Sydney Olympic Park Master Plan 2030 Review 2016

City of Sydney Submission on the Sydney Olympic Park Authority's Master Plan 2016 Review

Figure 2: Table 4.1 extracted from SOPA Master Plan Section 4

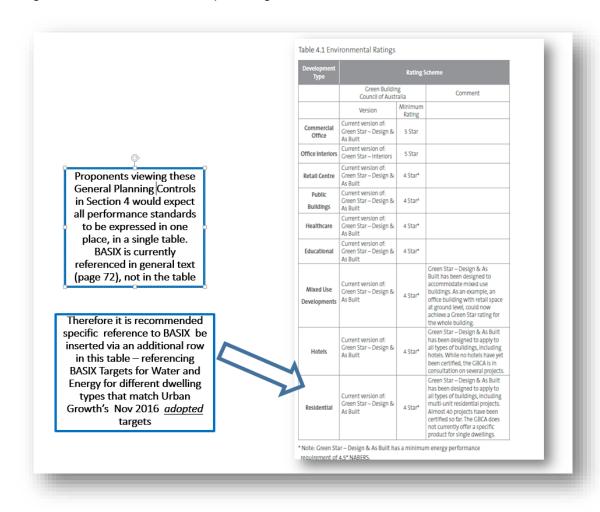
Guidelines. Updates to table 4.1 from the 2010 version are noted. Some international hotel chains use other well regarded rating methods and the Masterplan could reflect this in column 4 of the table, providing alternative compliance pathways.

It is recommended that Master Plan <u>Section 4 - General Controls and Guidelines</u> reference BASIX (without reference to specific targets²) with regard to residential development, potentially by making specific reference to key enablers of strong environmental performance – such as excellent solar access opportunities and connectivity to the existing precinct-scale recycled water scheme

Development proponents and their consultants would expect the table to reflect *all* environmental performance standards for the main building types/uses that occur within the precinct. Inclusion of BASIX in the table is logical, irrespective of the difference between SEPP-legislated performance and other rating tools. The table should refer to the local Energy and Water targets³ that should apply to residential development within the precinct. As indicated in point 7 above, these targets should align with Urban Growth's adopted targets for the Parramatta Road corridor.
